Monday, January 9, 2023  
PERMIT MODIFICATION APPROVAL  
Horizontal 6A / New Drill

Re: Permit Modification Approval for ROTH 6H  
47-069-00349-00-00

**Freshwater Casing Depth Shortened, Surface Owner Re-Notice**

**RE: Proposed Expedited Modification:**

# Proposed Drilling Program

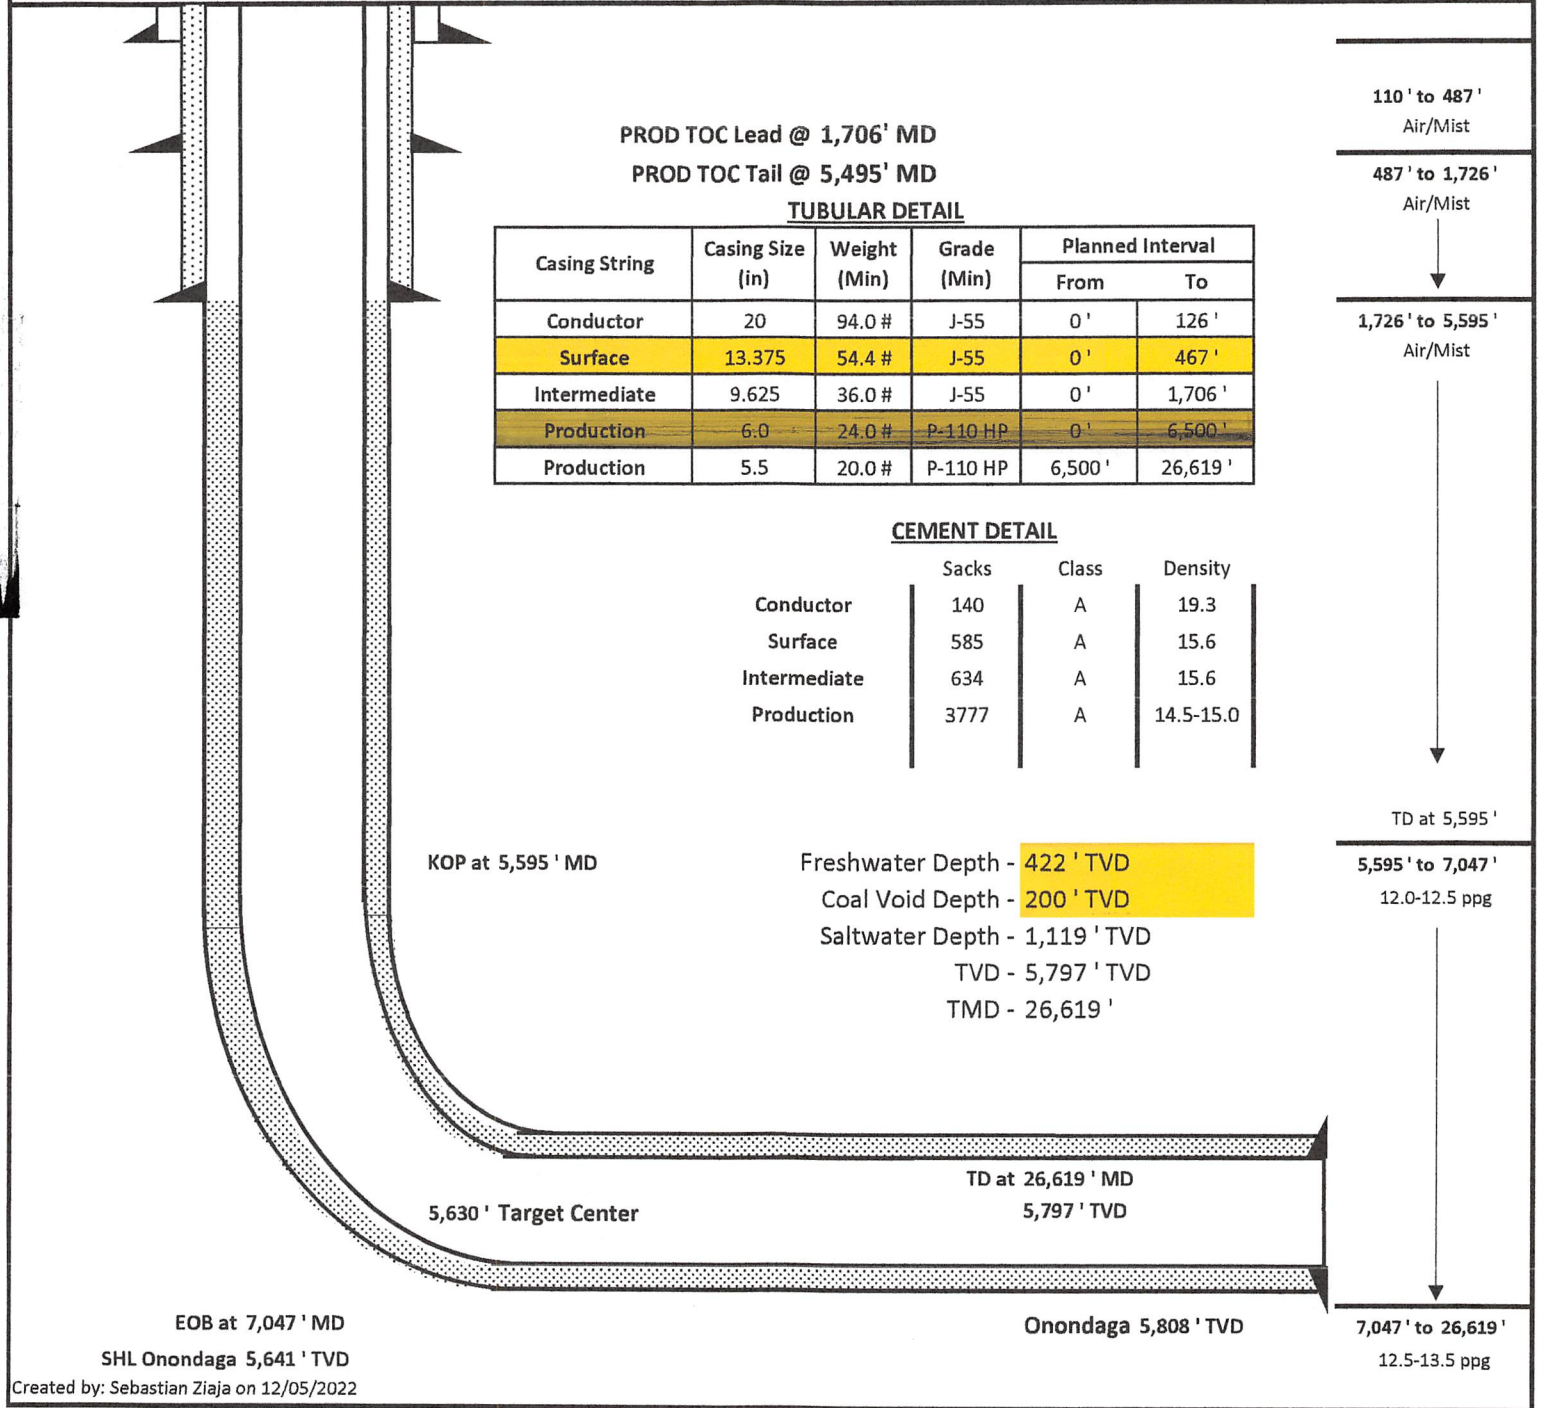
Enclosed please find the required documents to modify the above mentioned wells. We would like to modify the FW Casing Depth on these wells. This well is situated on the Roth's property, in Richland District, Ohio County, West Virginia.

| <b>TYPE</b>  | <b>Size (in)</b> | <b>New or Used</b> | <b>Grade</b> | <b>Weight per ft. (lb/ft)</b> | <b>FOOTAGE: For Drilling (ft)</b> | <b>INTERVALS: Left in Well (ft)</b> | <b>CEMENT: Fill-up (Cu. Ft.)/CTS</b>  |
|--------------|------------------|--------------------|--------------|-------------------------------|-----------------------------------|-------------------------------------|---------------------------------------|
| Fresh Water  | 13 3/8"          | New                | J-55         | 54.4#                         | 467'                              | 467'                                | 585 sx/CTS                            |
